ADDENDUM NO. 2 TO ADA/PROWAG CIVIL RIGHTS GRIEVANCE

City of Bloomington, Indiana

717 S. Henderson Street — Supplemental Submission: Unsigned Construction Obstructions Are a Citywide Pattern, Not an Isolated Occurrence

Re: Addendum No. 2 to ADA/PROWAG Complaint dated July 7, 2026 — 717 S. Henderson Street

Fig. 18: Prior curb ramp at the northeast corner of First Street and Mitchell Street (Google Street View, April 2026).

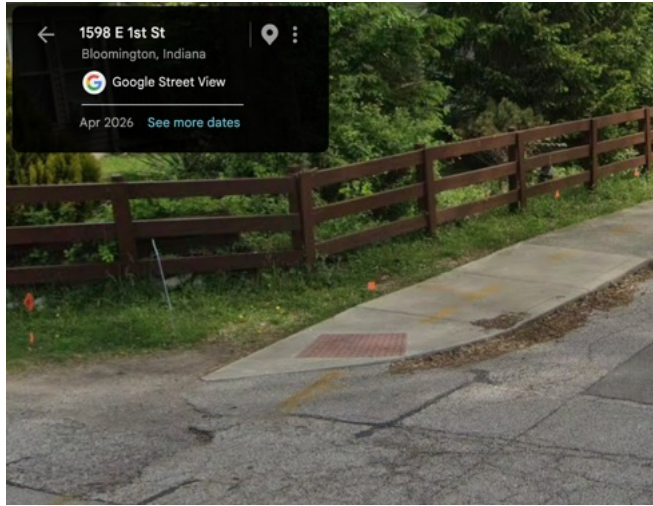
A compliant curb ramp previously existed at the northeast corner of First Street and Mitchell Street. Current construction has converted this ramp to loose gravel, with no signage posted.

Fig. 19: The same ramp reduced to gravel by current construction, with no signage posted (complainant's photograph).
